1722B – PROPOSAL FOR ENHANCED CONTROL FORMATS

DON PANNELL
10 MAR 2020

Overview

IEEE 1722b – Larger bus_id size – Proposal for FlexRay

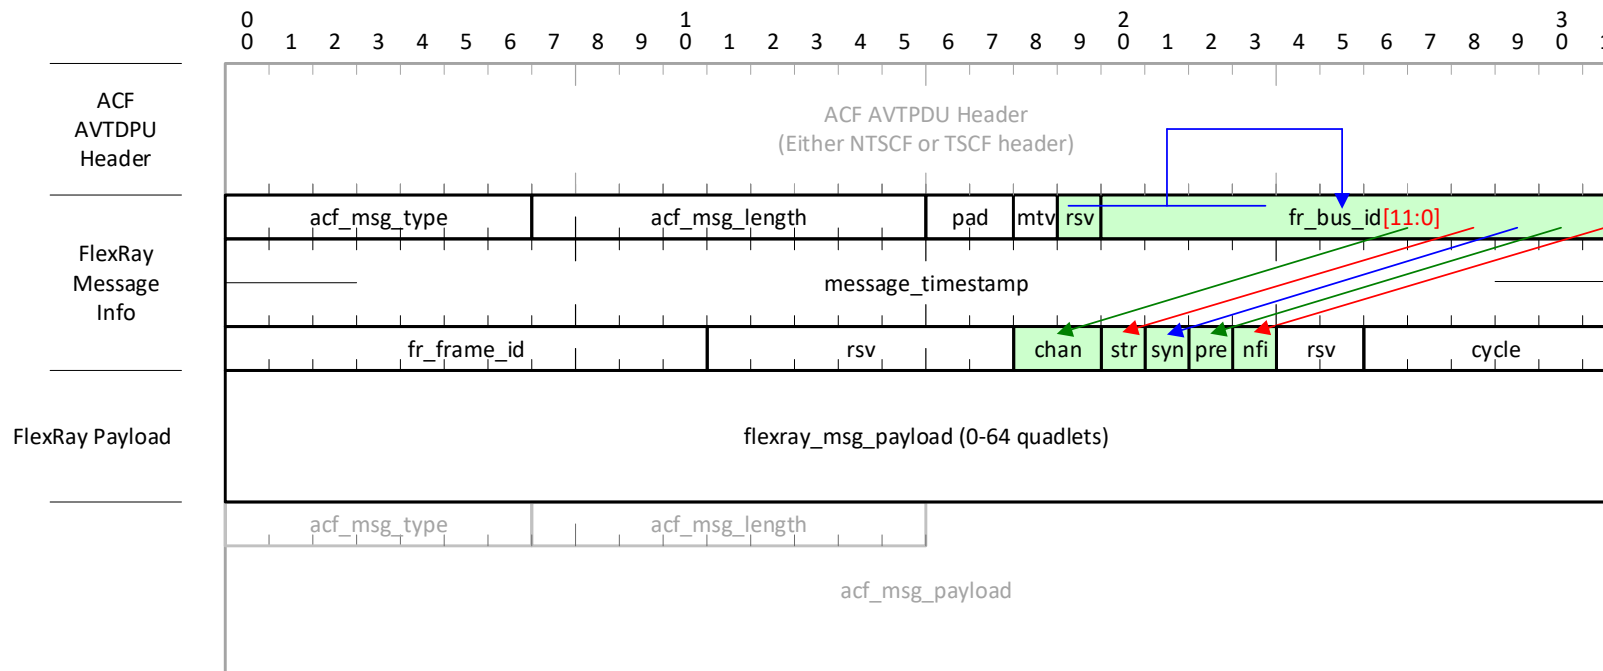
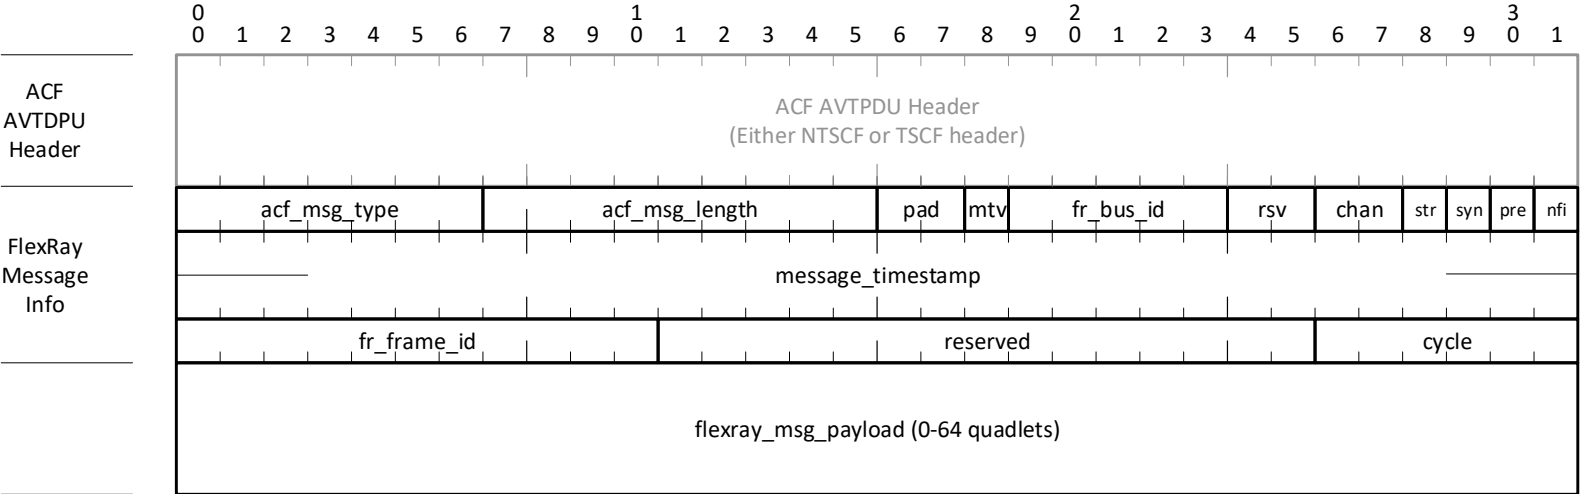
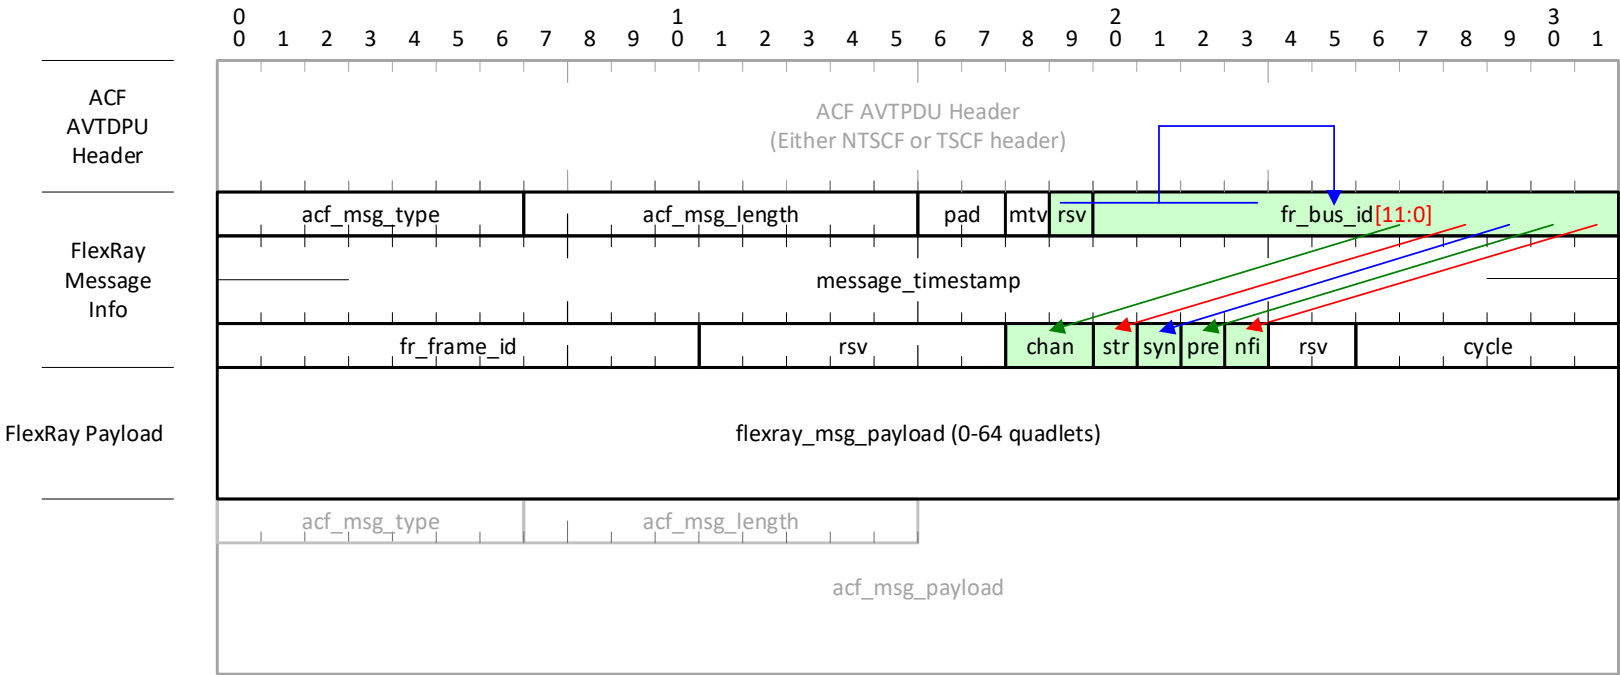
- Move the chan (source channel), str (startup), syn (sync), pre (payload preamble), & nfi (null frame indicator) bits to previously reserved bits as shown to free up room for the expanded fr_bus_id
- The fr_bus_id is shifted right by 8 bits & expanded to 12 bits leaving a rsv bit

IEEE 1722b – Larger bus_id size – Proposal for MOST

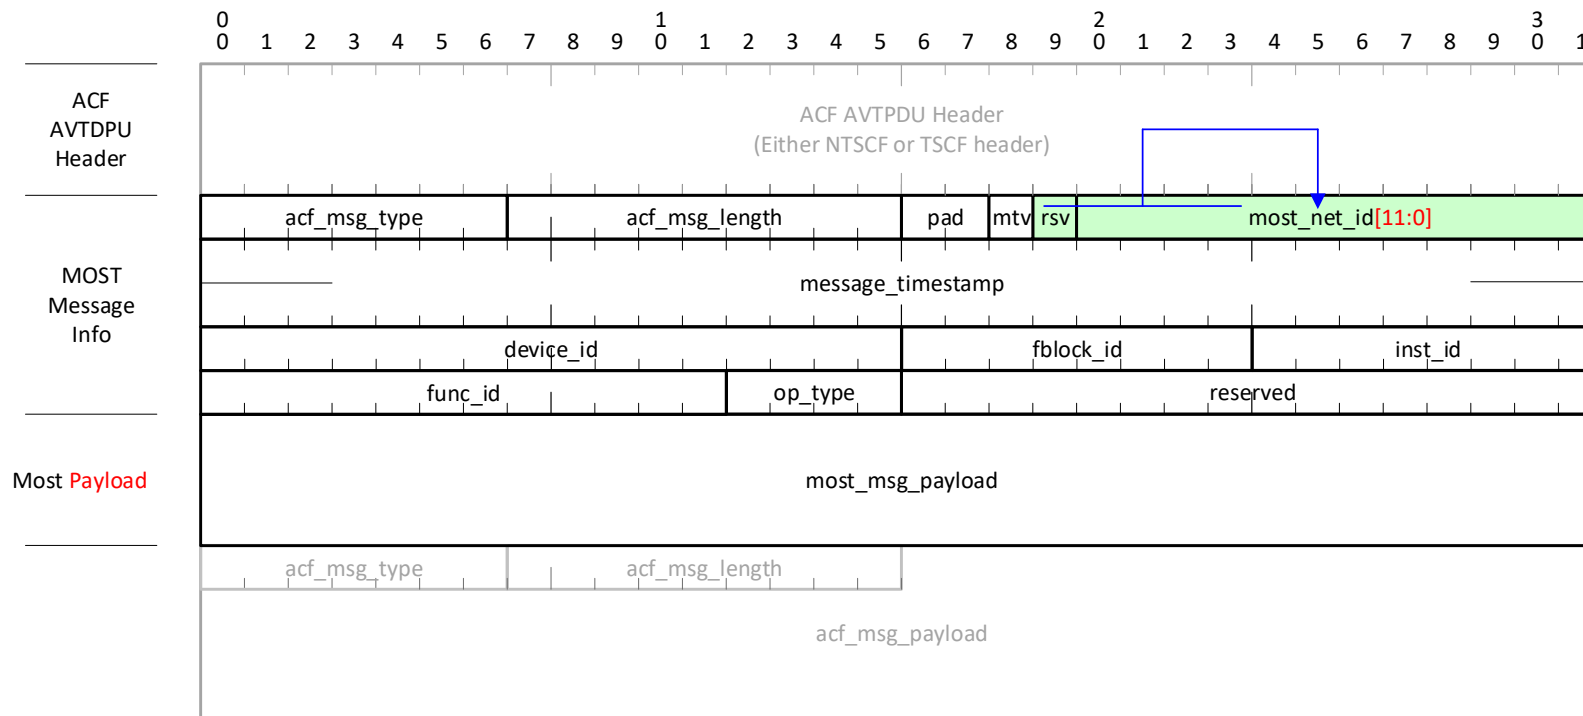
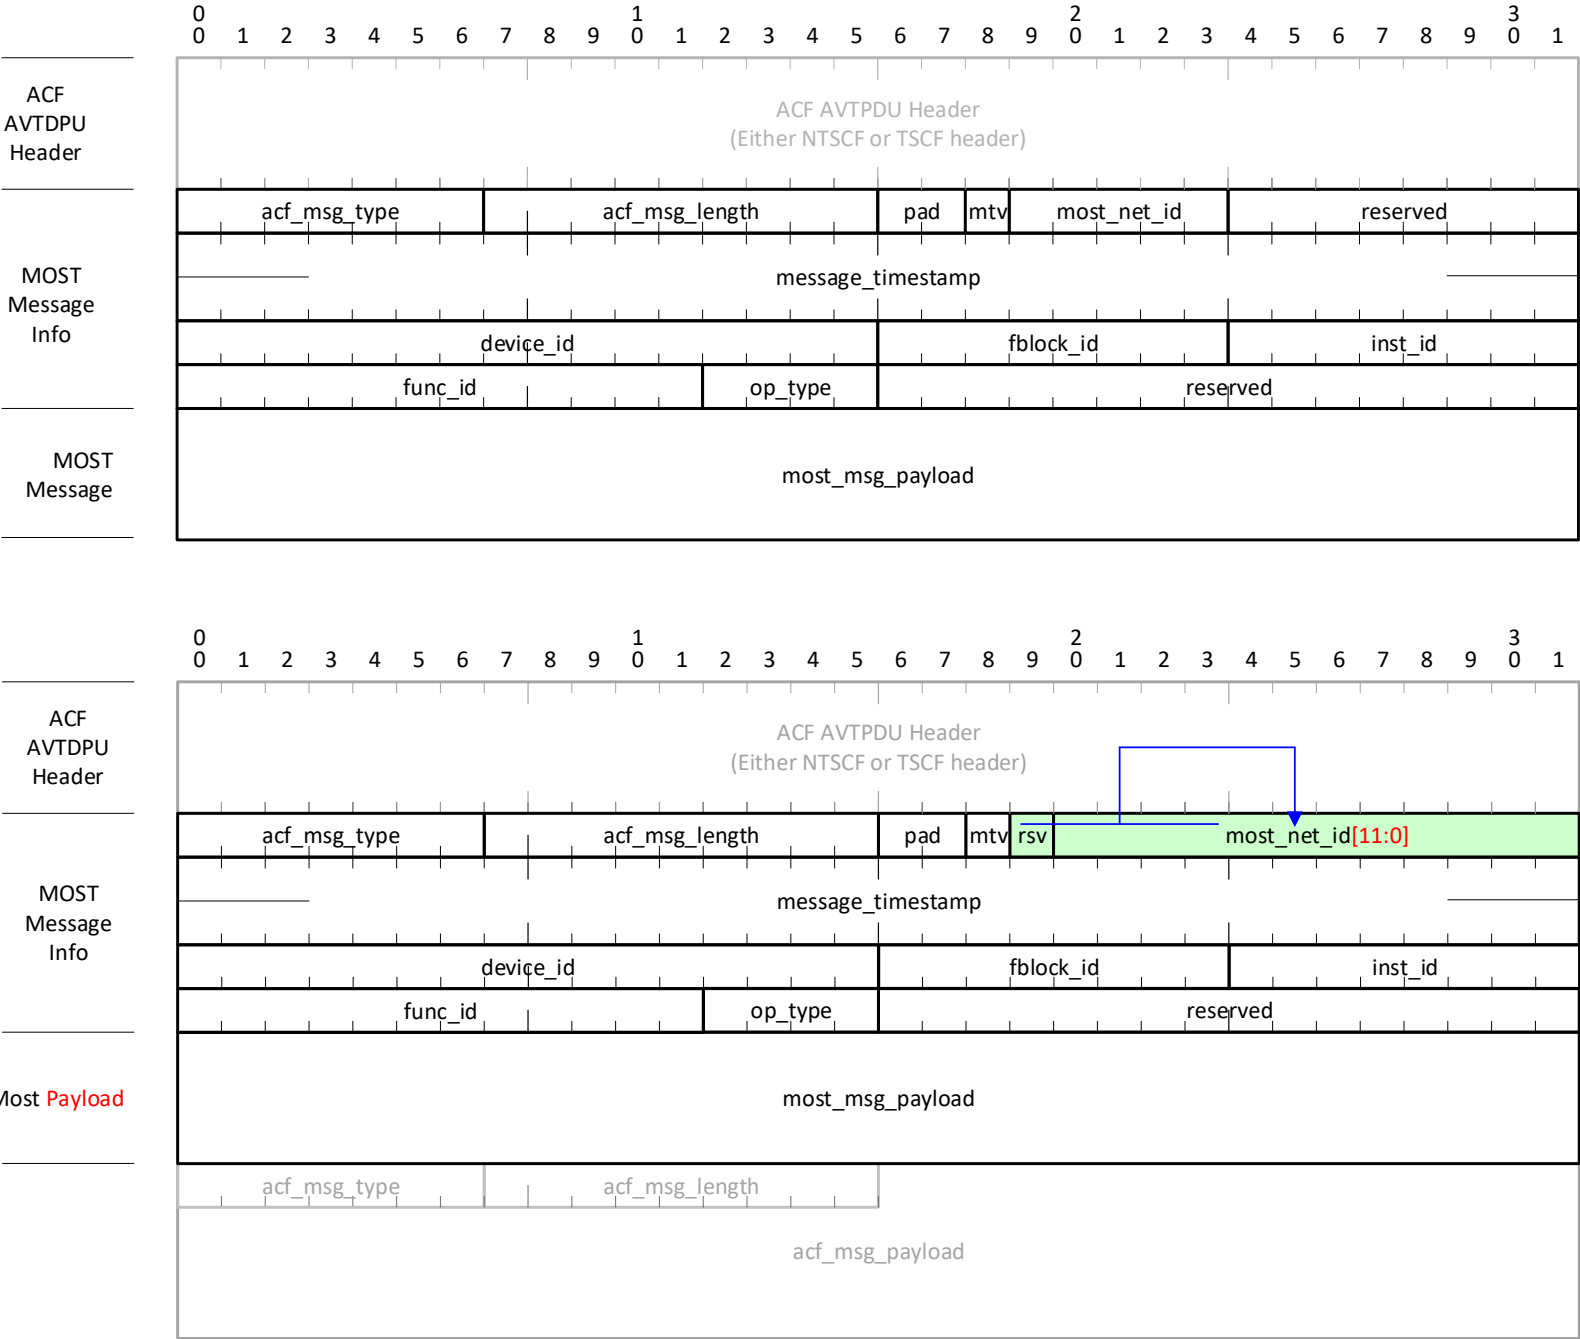
- The most_net_id is shifted right by 8 bits & expanded to 12 bits leaving a rsv bit
- The lower 8-bits of the new most_net_id previously was reserved bits

IEEE 1722b – Proposal for New Checksum Message

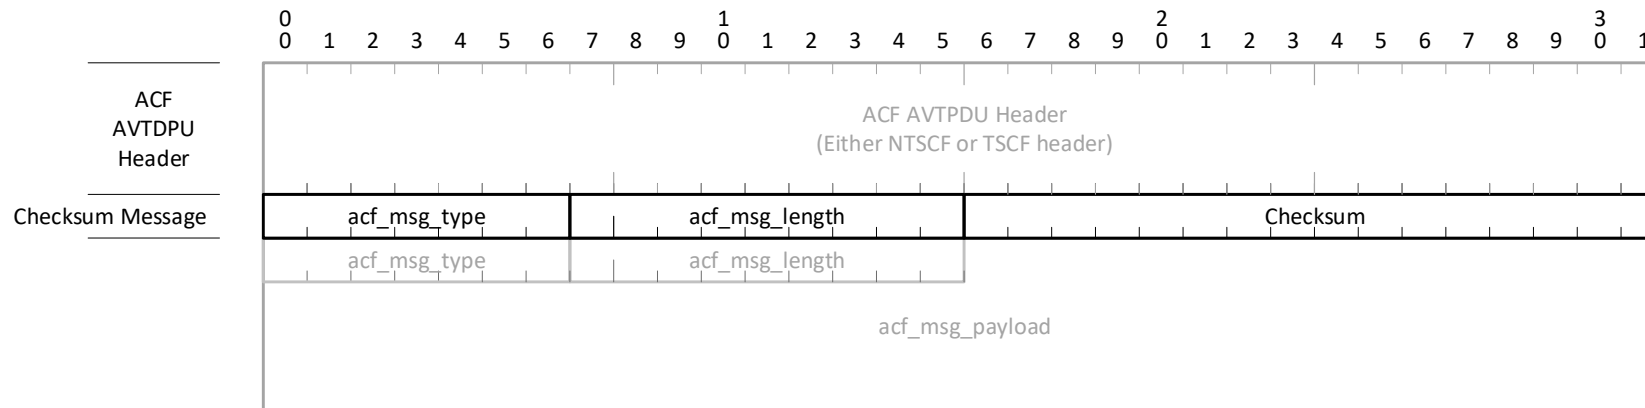
- Some safety systems want to verify that a message has not been corrupted end-to-end & this needs to be done after the Ethernet CRC has been removed
- This proposal is to support a new single quadlet Checksum ACF Message type that when used, carries the checksum for the immediately previous acf_msg, in this same frame, for the previous message's acf_msg_length
- This is mainly needed as an enhancement for CAN & LIN, but when done this way it works for all acf_msg_types
- Rule of use: Before acting on a current message, a check needs to be made to see if there is a subsequent Checksum Message or not – this is not hard to do
